D2.2 Comment

Annex 162 (CA), 162A/B/C/D

Chris DiMinico
MC Communications/PHY-SI LLC/Panduit
cdiminico@ieee.org

162B.1.3.3 Mated test fixtures common-mode to differential-mode insertion loss

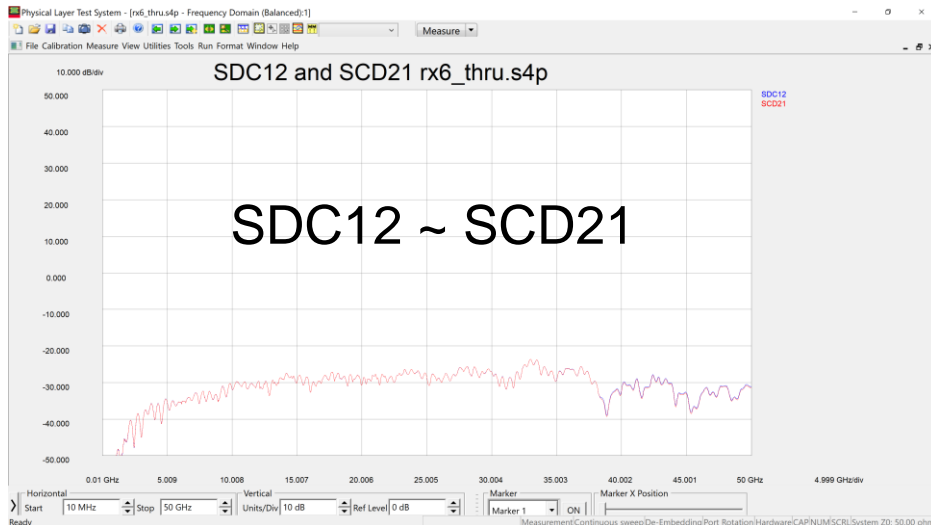
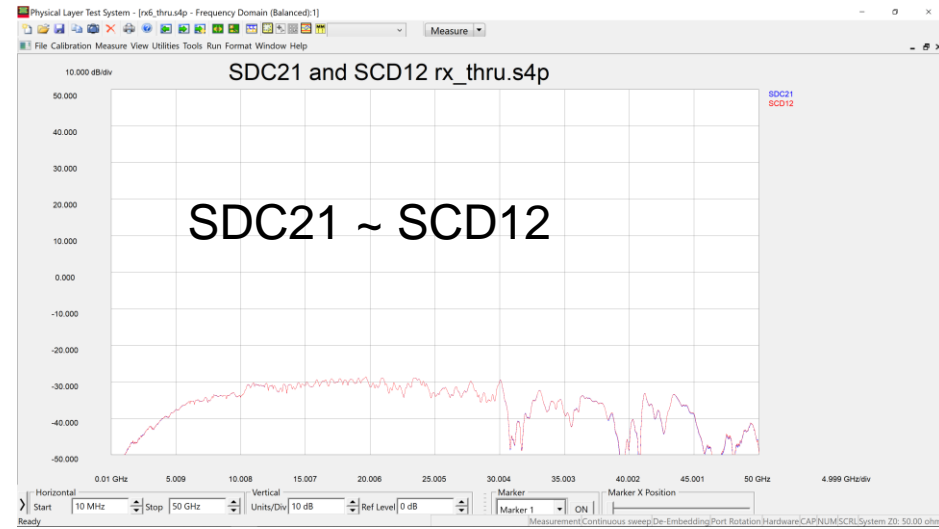
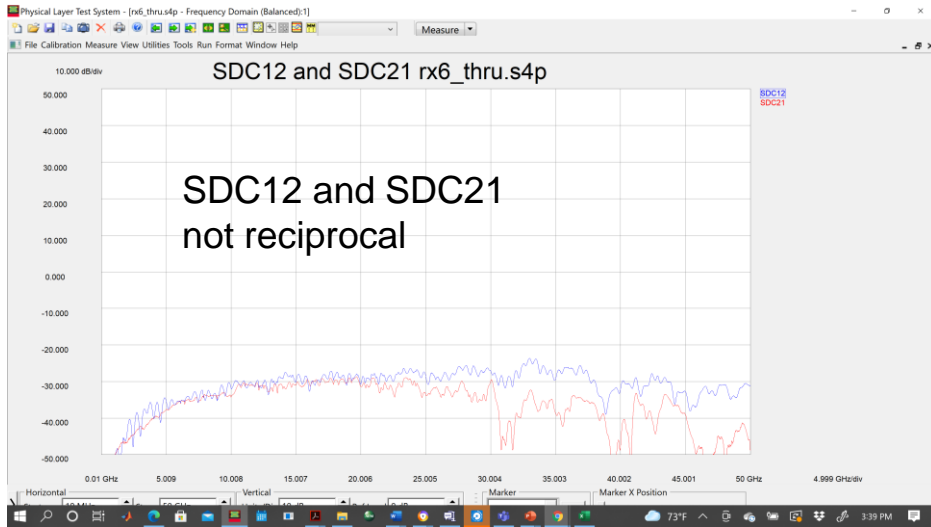
CI 162B SC 162B.1.3.3 P 297 L 36 # 138
 Dawe, Piers Nvidia
 Comment Type T Comment Status D MTF ILdc/ILdc

If common-mode to differential-mode insertion loss is what we want to control, that's ILdc. However, we want to control both ILdc and llcd, as we have both RLcd and RLdc specs in 120G. There is an argument that they are related, and specifying one is enough, but I'm not sure it always holds.

Specify both llcd and ILdc. It may be possible to specify one in one direction and the other in the other: Sdc21 and Sdc12, or Sdc21 and Scd12, where 1 is an input (instrument connector that would be connected to a pattern generator) and 2 is an output. I haven't thought through which we need, or maybe we need all four. It is simpler to require all four.

Error ILcd should be ILdc

- As these are test fixture specifications, SDC12, SDC21,SCD12, and SCD21 should be specified

Need a minimum of two measurements
SDC12 and SDC21
SCD12 and SCD21
SDC12 and SCD12
SDC21 and SDC21

PROPOSED ACCEPT IN PRINCIPLE.
 This comment does not apply to the substantive changes between IEEE P802.3ck D2.2 and D2.1 or the unsatisfied negative comments from previous drafts. Hence it is not within the scope of the recirculation ballot.
 However, the proposed change is an improvement to the draft.
 As pointed out by the comment both llcd and llcd of the MTF must be similarly constrained. Since ILcd12 and ILdc21 are reciprocal and ILcd21 and ILdc12 reciprocal, the insertion loss mode conversion can be constrained by measuring either llcd (or llcd) in both directions. The text as written was intended to require this but the wording could be improved.
 Also, the variable "llcd" should be "llcd" to correctly reflect the subclause title and text.
 Change: "measured at either test fixture test interface"
 To "measured in both directions"
 and
 Change variable name "llcd" to "llcd".

162B.13.3 Mated test fixtures common-mode to differential-mode insertion loss

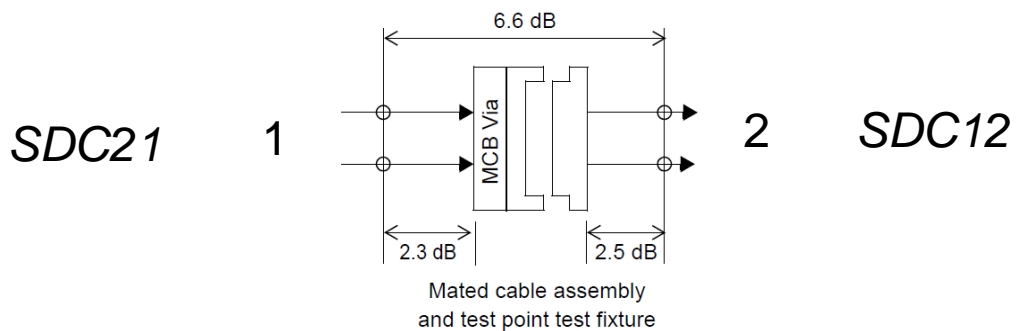
- Minimal changes to the draft
 - Correcting IL_{cd} to align with subclause description
 - Change "the mated test fixture measured at either test interface" to "the mated test fixture measured in both directions"

Need a minimum of two measurements
SDC12 and SDC21

162B.1.3.4 Mated test fixtures common-mode to common-mode return loss

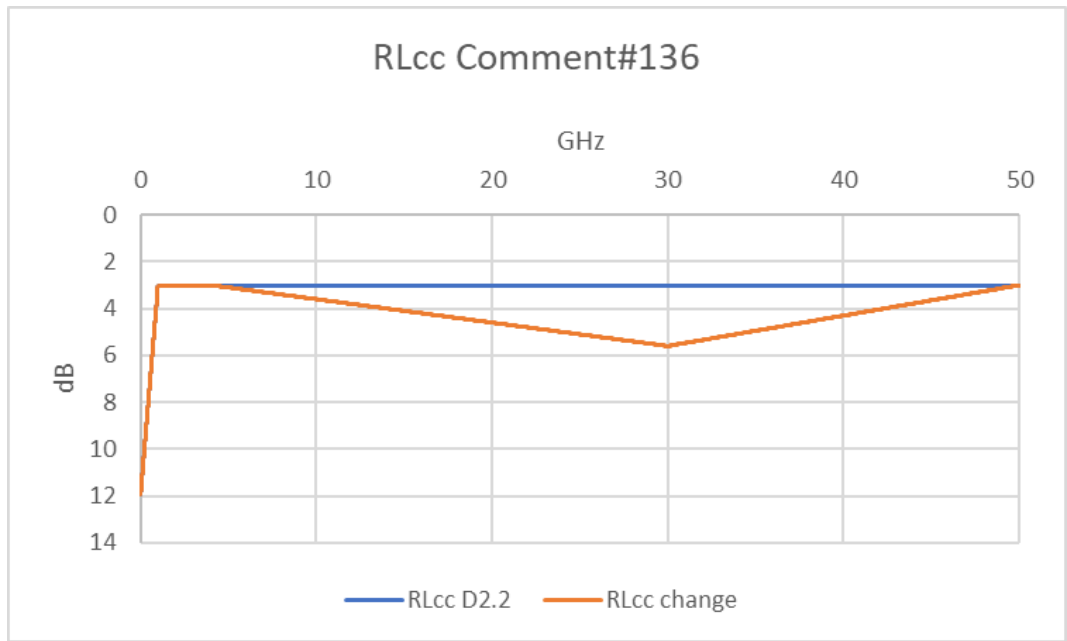
Just as for the cable RLcc spec: this 3 dB becomes useless when the MCB trace loss is half of 3 = 1.5 dB (16 GHz).

As for the cable RLcc spec but 1 dB lower to 30 GHz, easing up to 50 GHz: 12 -9f dB 0.01 <= f <1, 3 dB 0.5 <= f <= 4 GHz, 2.6+0.1*f dB 4 < f <= 30 GHz, 9.5-1.3*f dB 30 < f <= 50 GHz. f is in GHz.

12 -9f 0.01 <= f <1
 3 1 <= f <4 GHz
 2.6+0.1f 4 <= f < 30 GHz
 9.5-0.13f 30 <= f <= 50 GHz

PROPOSED REJECT.
 The comment and suggested remedy does not provide sufficient information or justification to support a change to the draft.
